PLANS AND DOCUMENTS referred to in the PDA DEVELOPMENT APPROVAL
Approval no: DEV2016/759
Date: 25 January 2017
Queensland Government

AMENDED IN RED
By: Chessa Lao
Date: 10 February 2025
Queensland Government

AMENDED IN RED
By: Essen Joseph
Date: 15-Feb-2022
Queensland Government

nra-co-lab™
© Copyright Noel Robinson Architects Pty Ltd.
KINGSFORD
527 GREGORY TCE
STAGING PLAN
89084C16
SK9100
DATE: 16/01/2017 5:18:11 PM
SCALE: 1 : 200 @A1
SCALE : 1 : 200@ A1

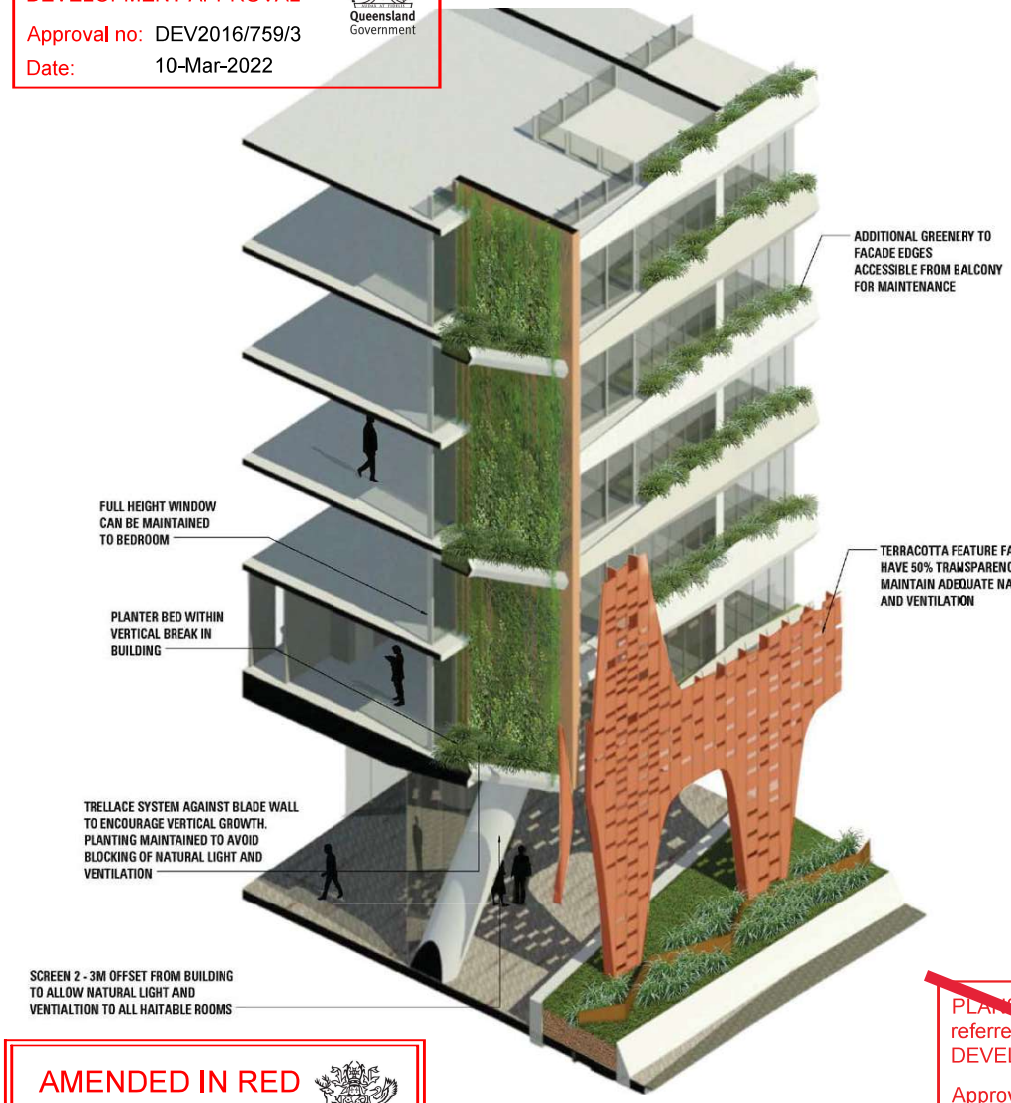
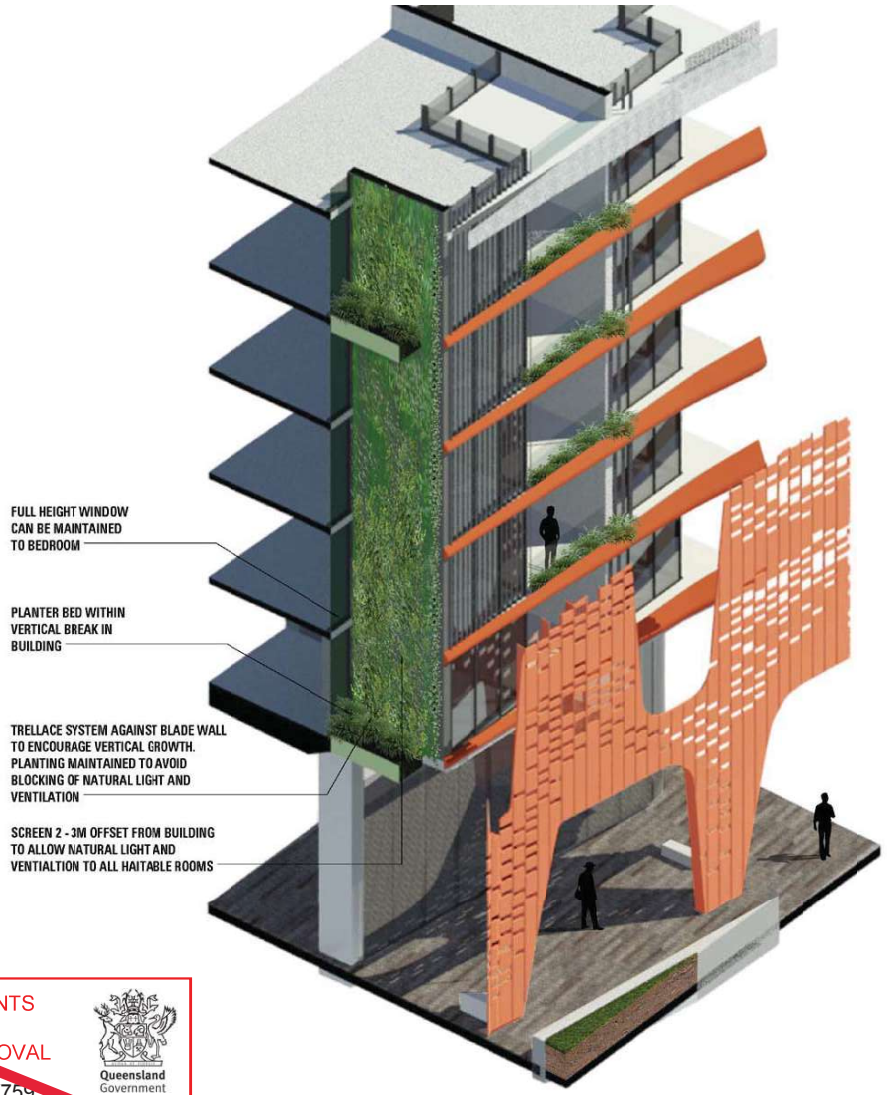
Detailed landscape architecture plans to be submitted, supported by details demonstrating the ability to establish and maintain the proposed vertical gardens, having regard for planter depths, soil/media volumes, irrigation and maintenance systems, access to light, and choice of appropriate species.

A VERTICAL TRELLIS SYSTEM IS PROPOSED EVERY 3 LEVELS TO ENCOURAGE SUFFICIENT GROWTH FROM EACH PLANTER BED. THE VEGETATION IS TO BE MAINTAINED EXTERNALLY VIA ABSEIL OR SIMILAR SYSTEM TO PROVIDE SAFE ACCESS FOR MAINTENANCE PERSONNEL TO ACCESS GREEN AREAS AND GLAZING TO PERFORM MAINTENANCE AND CLEANING.
